RESOURCE CONSENT APPLICATION LU23031 & SC23032

REQUEST FOR FURTHER INFORMATION

I refer to the land use consent LU23031 & SC23032 seeking to establish a housing complex consisting of 24 residential units and subsequent subdivision, and further consent under the National Environmental Standard for Assessing and Managing Contaminants in Soil to Protect Human Health.

Figure 1

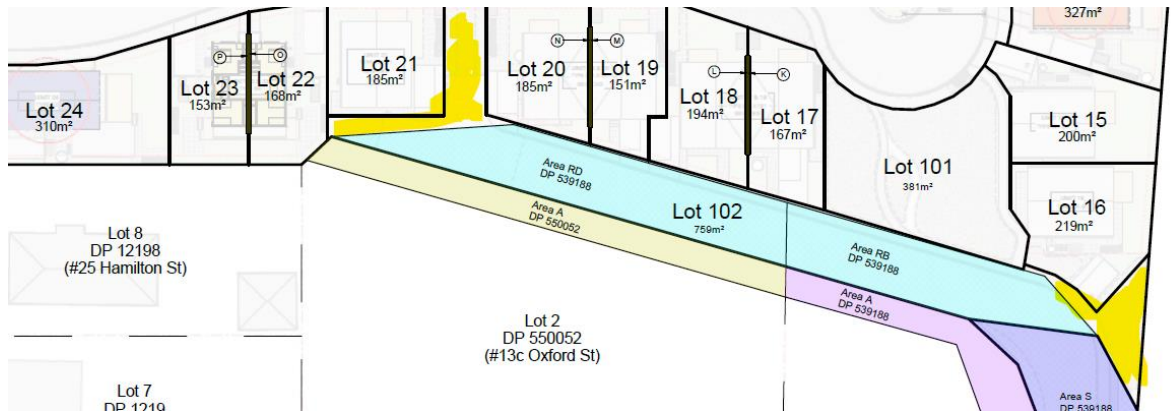
1. Confirm if the application is for a managed social housing complex and demonstrate how this will continue when subdivided, as the proposed subdivision alters the ownership model.
2. GDC will not manage the green area (Lot 101). It will remain in the control and management of the Applicant. Please provide details on how the area will be managed to maintain amenity for the development and surrounding neighbourhood. E.g. frequency of mowing, litter picking etc. How will this maintenance continue following the subdivision?
3. Please provide details on how the pedestrian walkway and other common areas within the ROW will be managed by the joint owners (*highlighted yellow in Figure 1*)?

4. Further to point 3, given the number of parties subject to the ROW ownership and additional properties currently utilising it (Area RD, RB, A, A and S), where do responsibilities lie in terms of general maintenance and street lighting? How will the cost share be dealt with?
5. Has a unit title subdivision with a body corporation type of mechanism been considered?

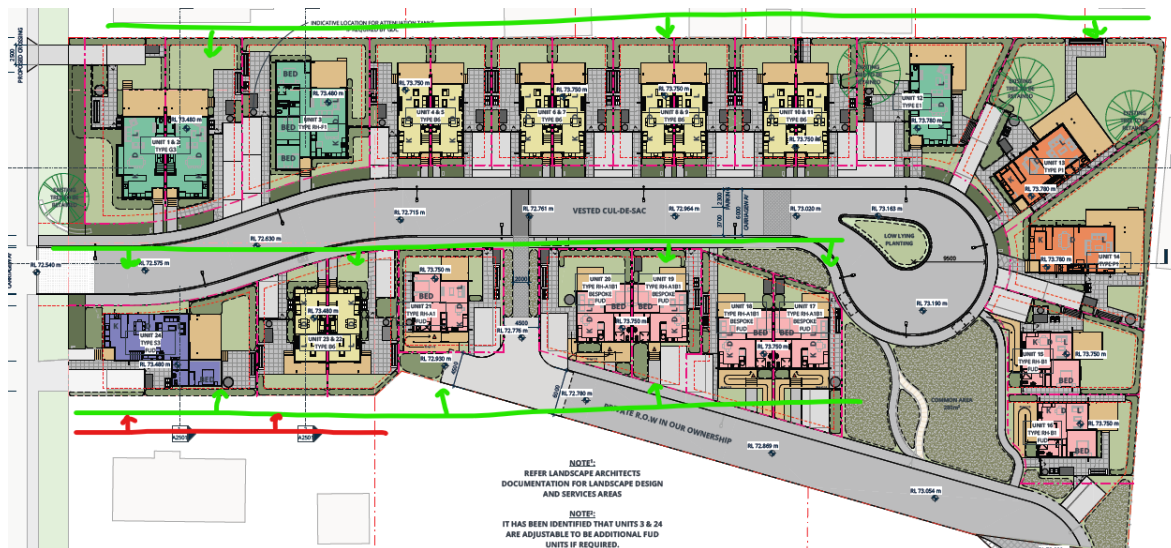
16. Provide elevations free from trees, shadows, fences etc. to clearly show the built form proposed.
17. Provide elevations for every unit or each unit typology if they are repeated through the development.
18. Provide northern and southern elevations of the complex as a whole, depicted by green lines below.
19. Provide an elevation of the built form facing the shared boundary with 25 Hamilton Street, depicted by red line below.
